D350-748-103
Job Sheet 162594

Part Name: AS350 / AS355 Stainless Steel Fwd Crosstube

DRAWING NO. REV. A
D350-748-143 SHEET 1 OF 4
TITLE SCALE
CROSSTUBE (AS 350/355 HI FWD) NTS

DRAWING NO. D350-748-143	TITLE CROSSTUBE	REV. A	DART AEROSPACE LTD ENGINEERING ORDER		D.E.O. NO. D350-748-143-A-1	SHEET NO. SHEET 1 OF 1	SCALE NTS
DRAWN <i>q</i>	CHECKED <i>ASS</i>	MFG. APPR. <i>[Signature]</i>	APPROVED <i>[Signature]</i>		DE APPR. <i>[Signature]</i>		
DATE 15.11.18	DATE 15.11.18	DATE 16.02.19	DATE FEB 19 2016		DATE 2016.02.19

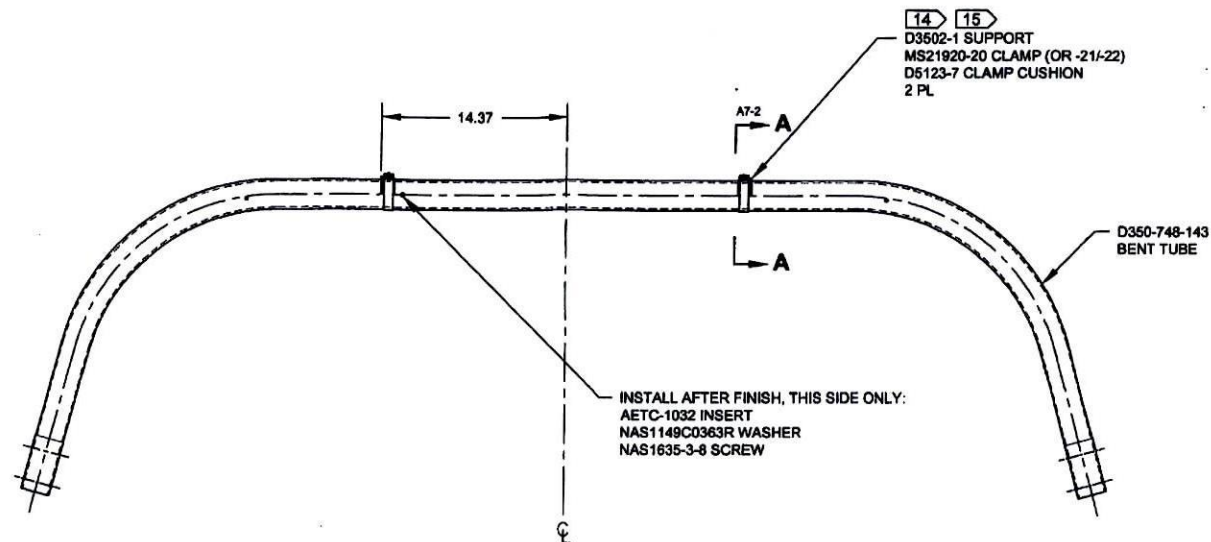
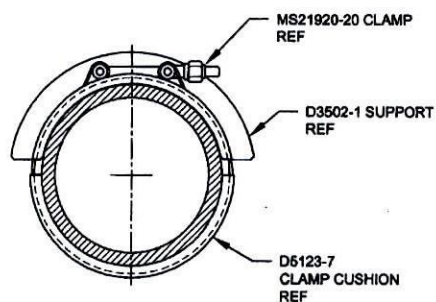
AMEND NOTE 2 (SHEET 1) AS FOLLOWS:
